HISTORIC AND DESIGN REVIEW COMMISSION

April 07, 2021

HDRC CASE NO: 2021-133
ADDRESS: 520 LEIGH ST
LEGAL DESCRIPTION: NCB 2739 BLK LOT 4F & PT OF 5F (AKA TRACT 6)
ZONING: IDZ,H
CITY COUNCIL DIST.: 1
DISTRICT: Lavaca Historic District
APPLICANT: Scott Jones/LABOR STREET COMMONS LLC
OWNER: Scott Jones/LABOR STREET COMMONS LLC
TYPE OF WORK: Construction of a multistory residential structure, site modifications
APPLICATION RECEIVED: March 17, 2021
60-DAY REVIEW: Not applicable due to City Council Emergency Orders
CASE MANAGER: Stephanie Phillips

The applicant is requesting a Certificate of Appropriateness to construct a new 2-story single family residence at the lot addressed 520 Leigh St.

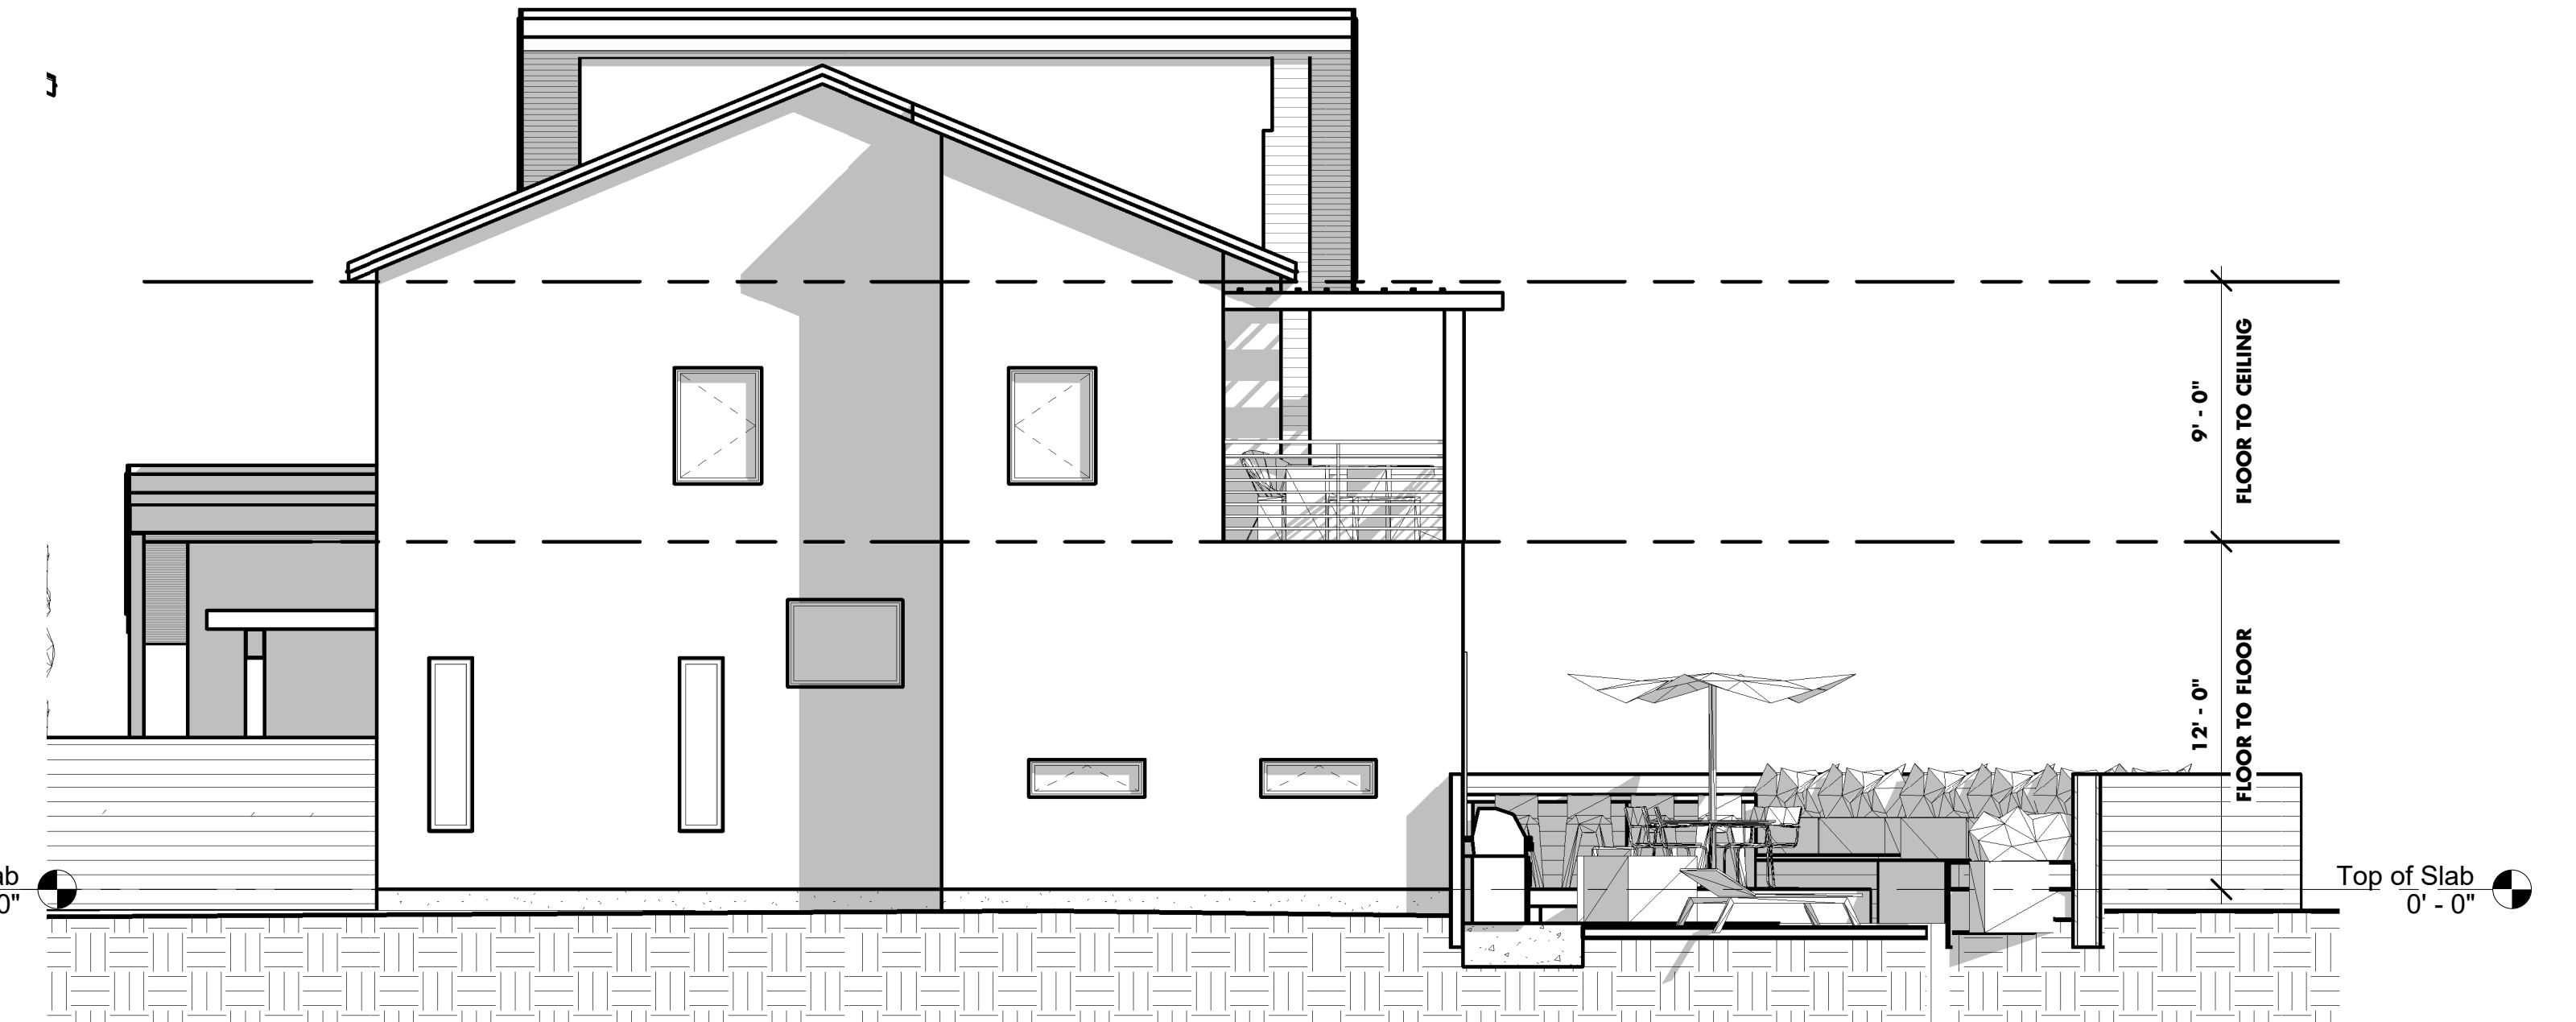
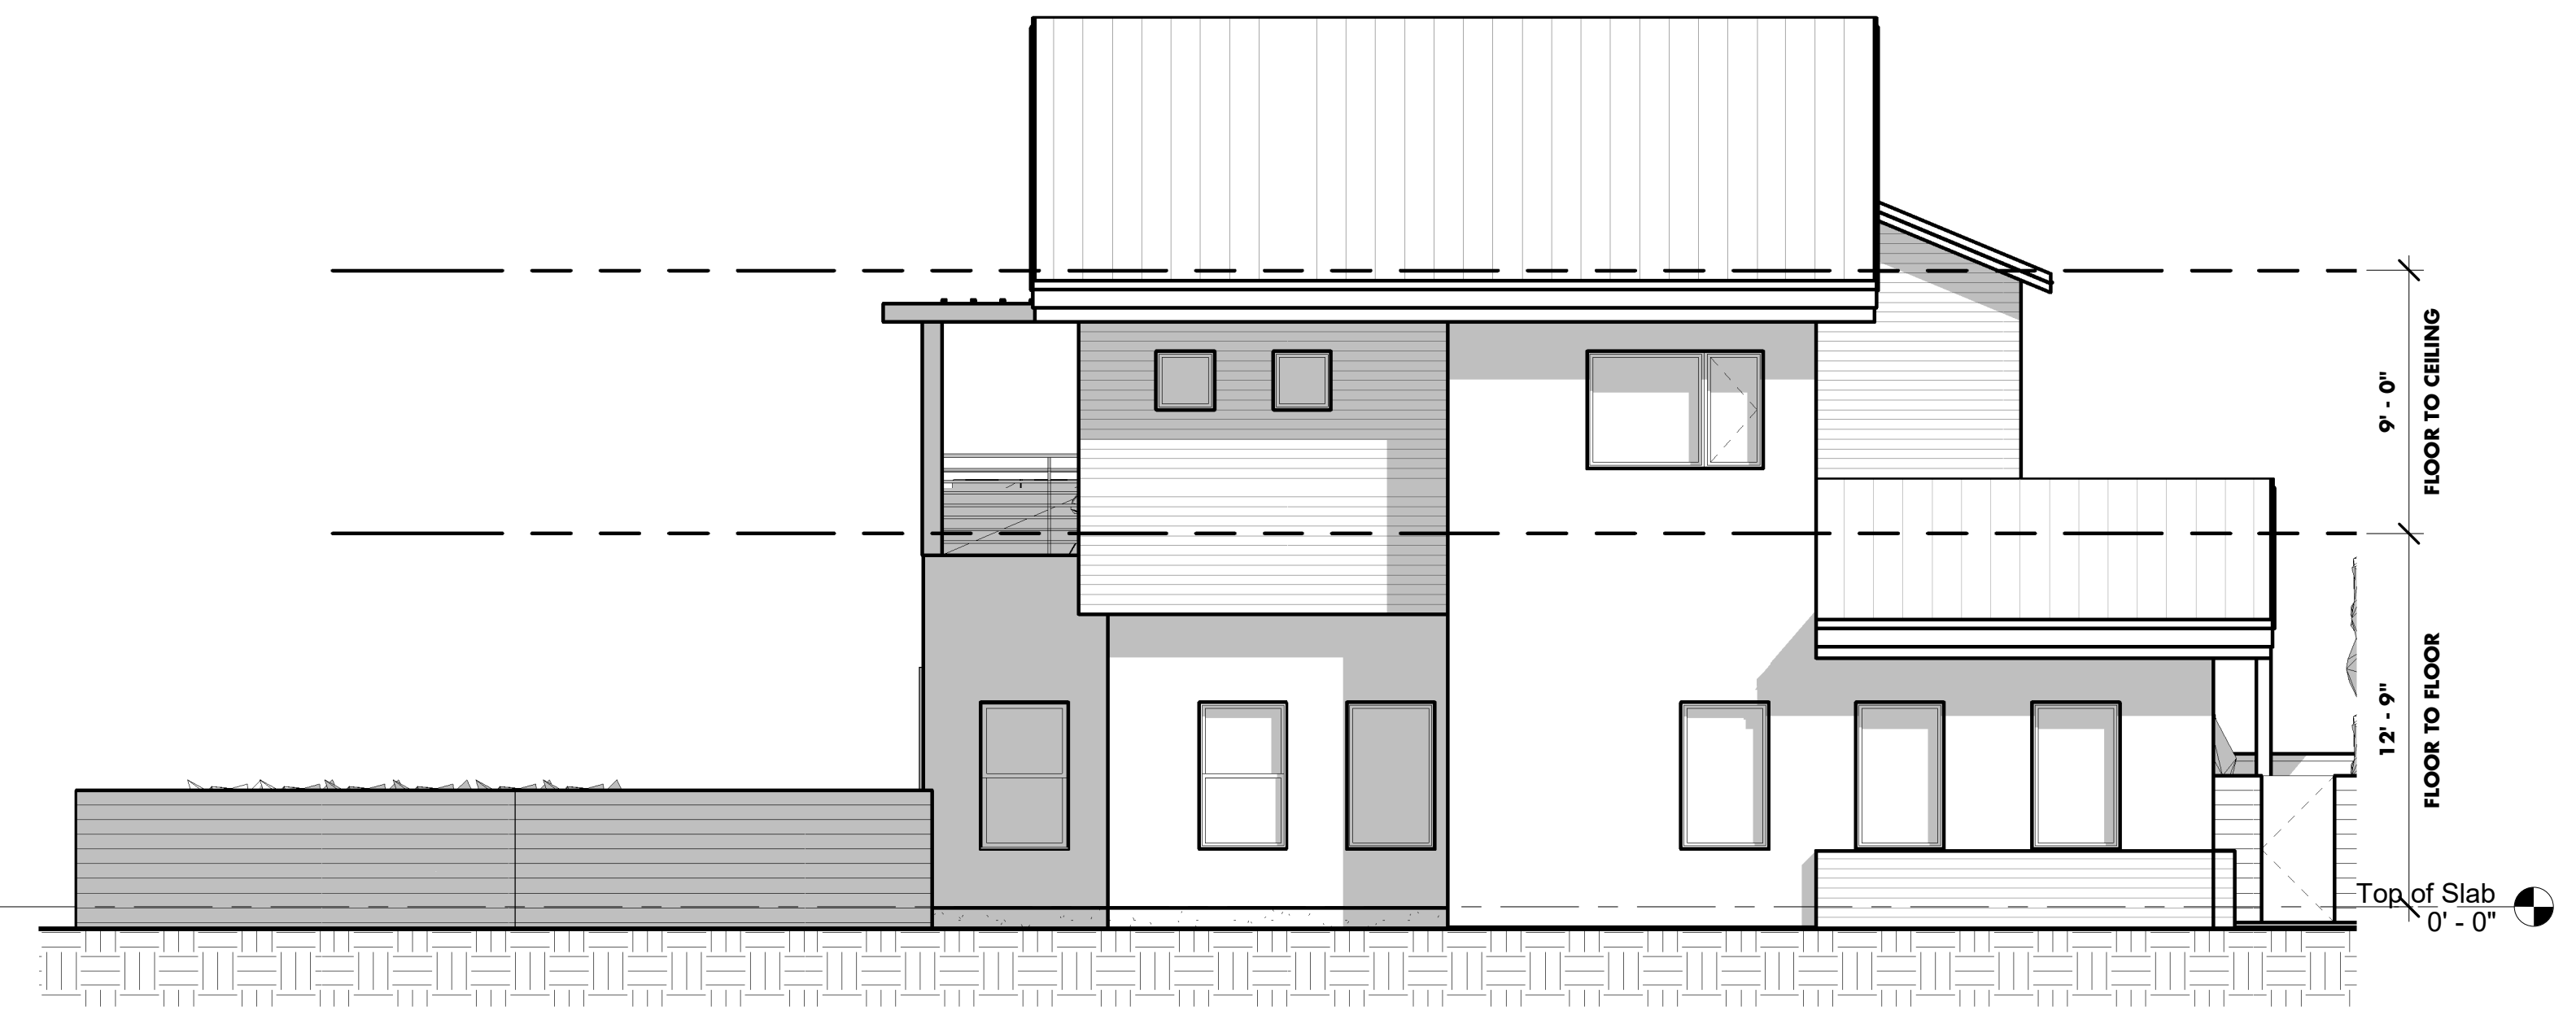
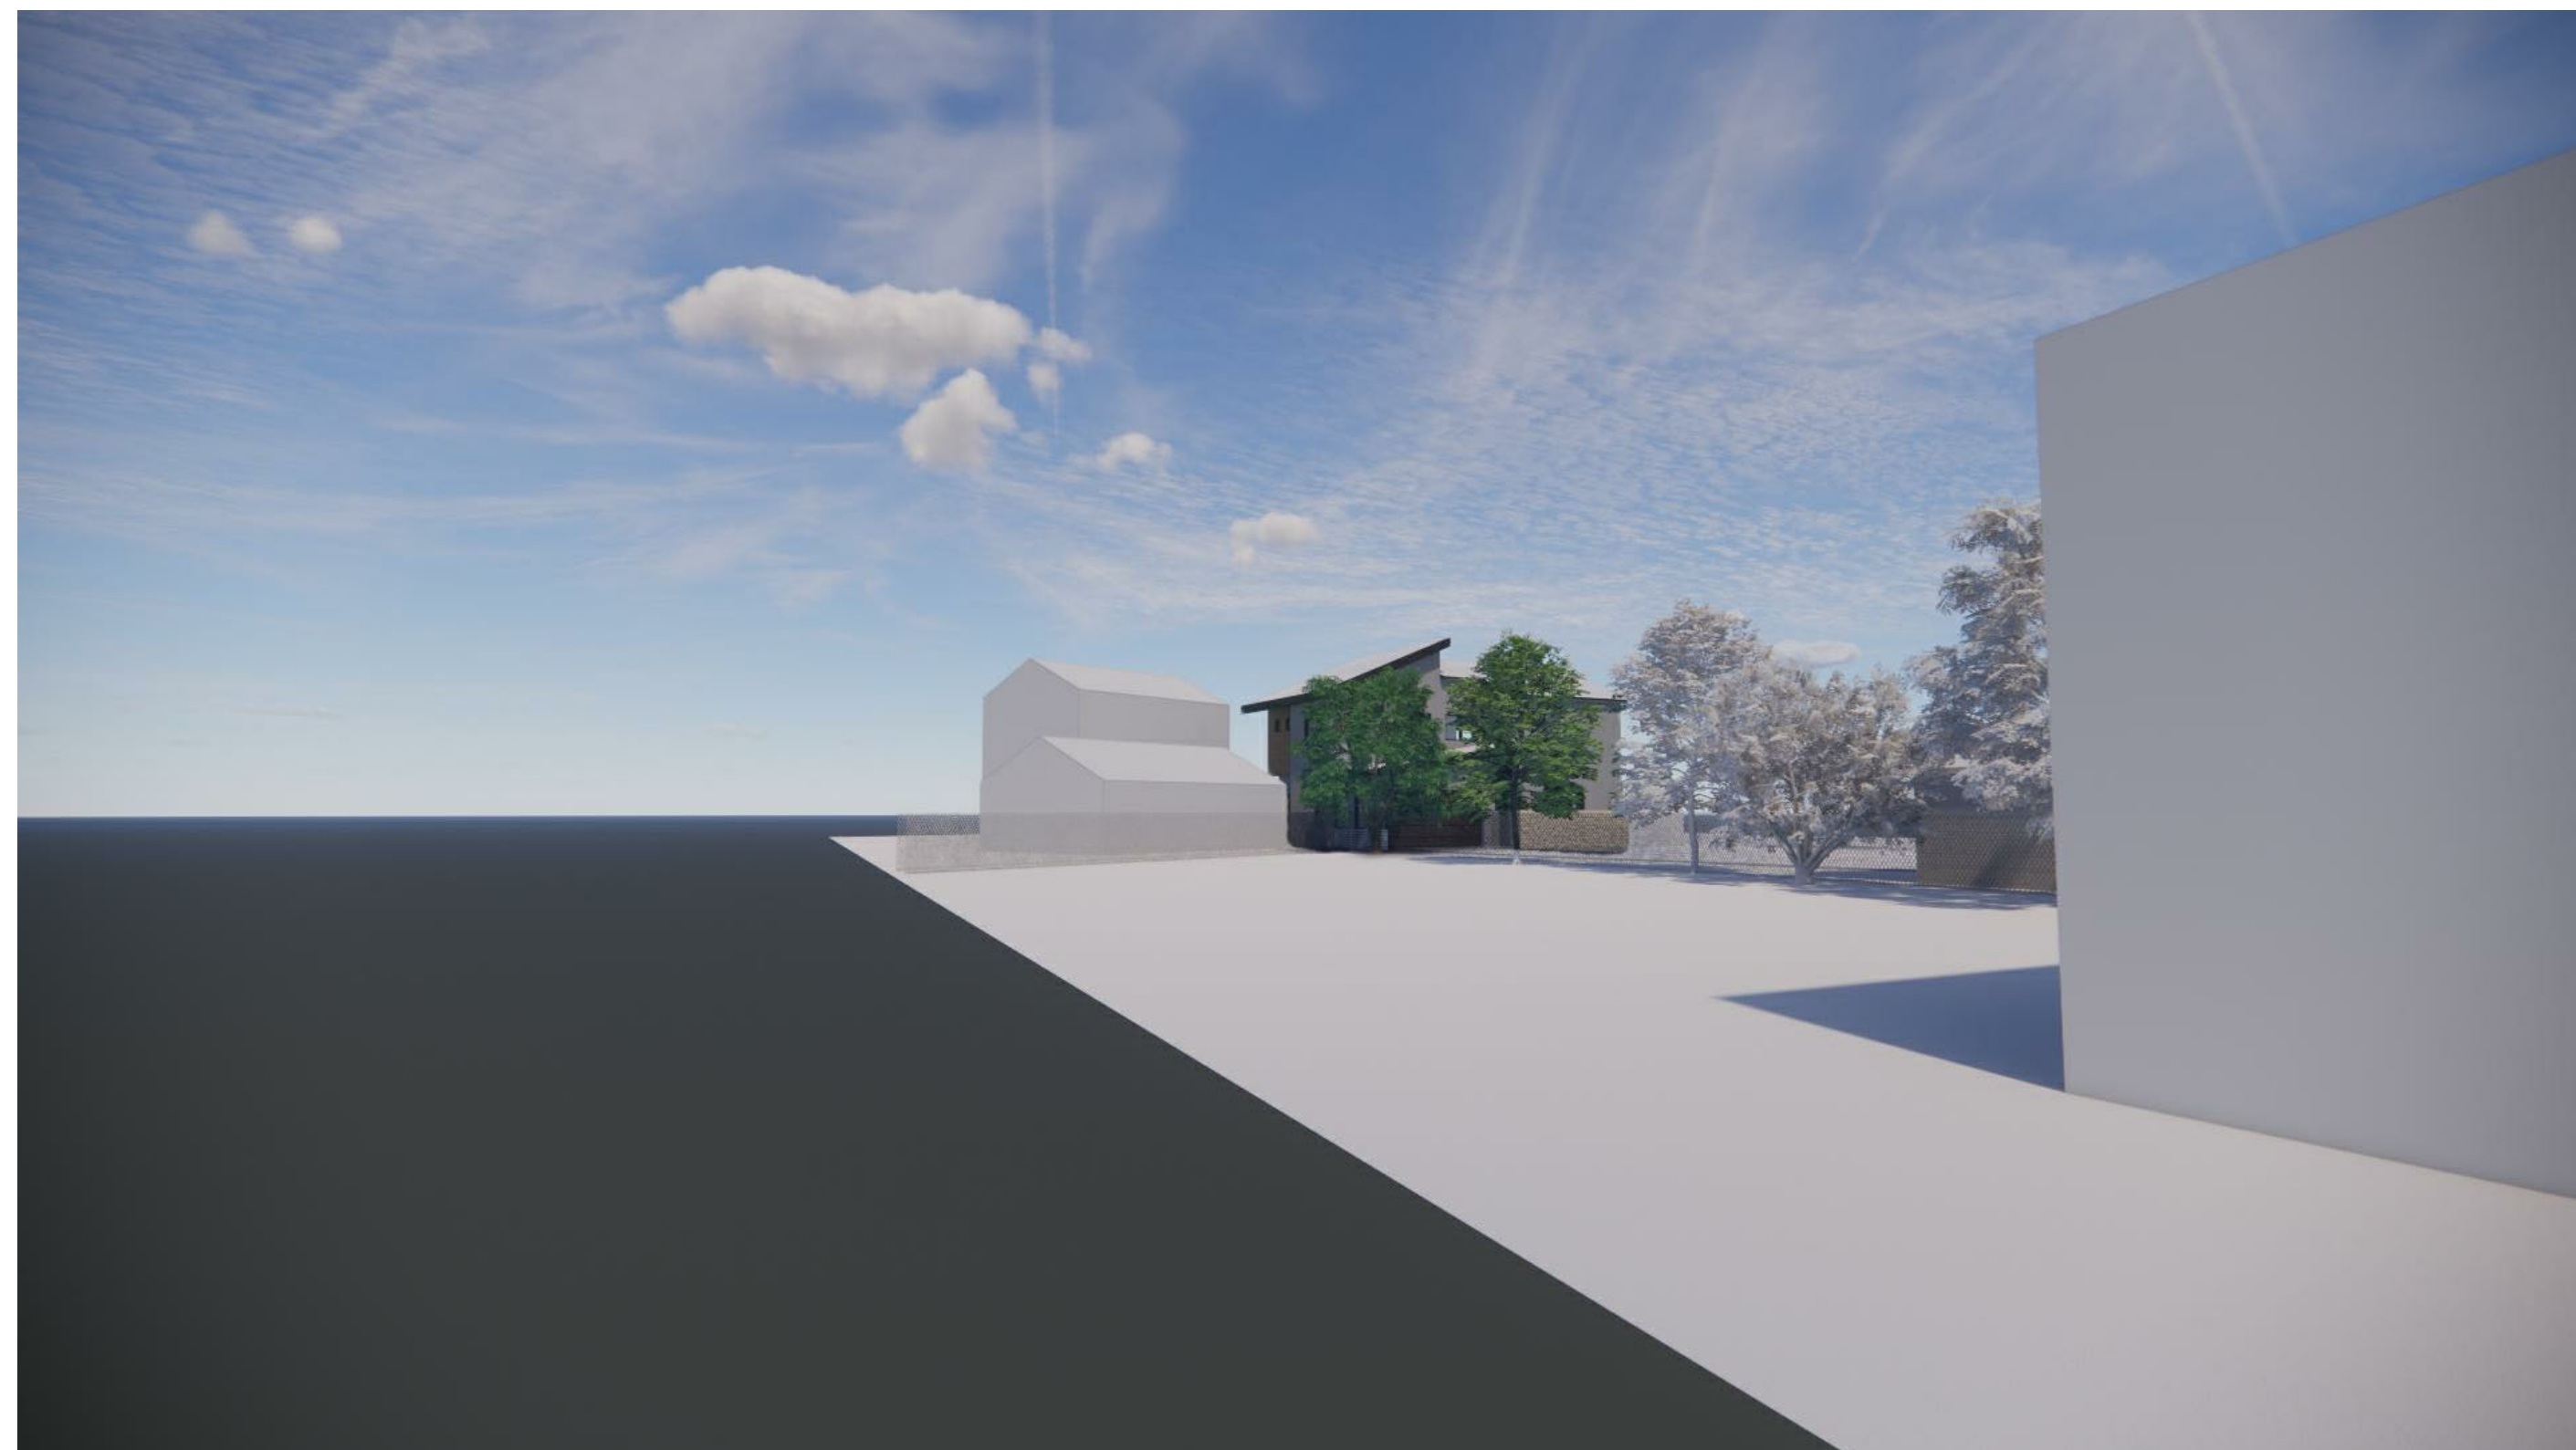
- j. FOUNDATION & FLOOR HEIGHTS – Per the Guidelines for New Construction 2.A.iii., applicants should align foundation and floor-to-floor heights within one foot of floor-to-floor heights on adjacent historic structures. Based on the submitted elevations, the proposed foundation is slab-on-grade with a minimal rise. Staff finds that the applicant should utilize foundation heights that are consistent with the Guidelines.

- k. ROOF FORMS – The applicant has proposed a multi-slope roofline. The primary roofline is a side gable with a low-sloping shed roof extending to the north. . Staff generally finds these roof forms to be consistent based on the surrounding context, but finds that in context with the proportions of the home, additional roof solutions should be explored to visually reduce the mass of the flat roof portion, primarily on the north and east elevations.

- l. WINDOW & DOOR OPENINGS – Per the Guidelines for New Construction 2.C.i., window and door openings with similar proportions of wall to window space as typical with nearby historic facades should be incorporated into new construction. Per the elevations that the applicant has submitted, staff finds the proposed windows to be inconsistent with the Guidelines. The proposed sizes, configurations, and rhythm are not found historically within the district.

- p. WINDOW MATERIALS – The applicant has proposed aluminum clad wood windows, which may be consistent with staff’s stipulations. However, the proposed windows in terms of pattern, detailing, configuration, proportion, and inset are not consistent with the Guidelines.

- i. That the proposed structure be reduced in height and massing to be consistent with rear accessory structures found historically within the district (subordinate to primary structures), as noted in findings f and g.
- ii. That the applicant utilize foundation heights that are consistent with the Guidelines, as noted in finding i.
- iii. That the applicant incorporate roof forms that are more consistent with the surrounding historic context as noted in finding j.
- iv. That the applicant incorporate appropriate traditional window sizes and proportions and modify the overall fenestration pattern as noted in finding k.
